OhioEPA
Division of Surface Water

Response to Comments

Project: FirstEnergy Lake Shore Plant, National Pollutant Discharge Elimination System (NPDES) Permit

Ohio EPA ID #: 3IB00004

Parameter name: Mercury, Total (Low Level)

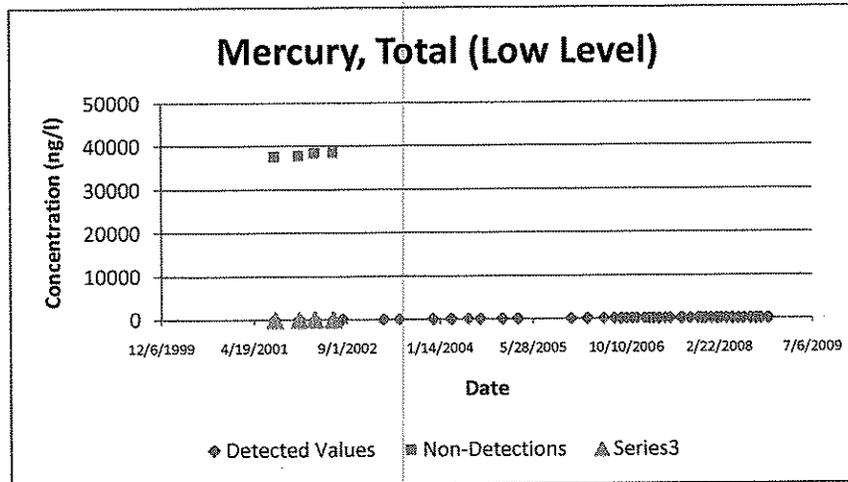
Comment 10: A proposed variance limit of 8-13 nanograms per liter (ng/l) was presented at the public meeting. That seems dangerously close to source data observed before the new permit limits go into effect, and are at the upper limits of the data distribution. If all permit holders request and receive variances, little or no mercury reductions will occur by 2010. If the company can document 2.9 ng/l, that should be the variance limit until a more stringent goal can be achieved.

Response 10: The difference between these values is the difference between the long-term average of the discharge (2.9 ng/l) and the average effluent limit.

An upper bound estimate is used because all effluents have some variability. For any treatment system, a limit set at the long-term average will result in the discharger being in violation approximately 50% of the time. Setting a limit that a discharger can consistently meet requires us to look at the variability of well-operated treatment systems.

Ohio EPA recommends a variance-based monthly average limit of 7.1 ng/l, based on the PEQ average statistic for Outfall 002. This represents the 95th percentile of the data reported. See the attached data for details.
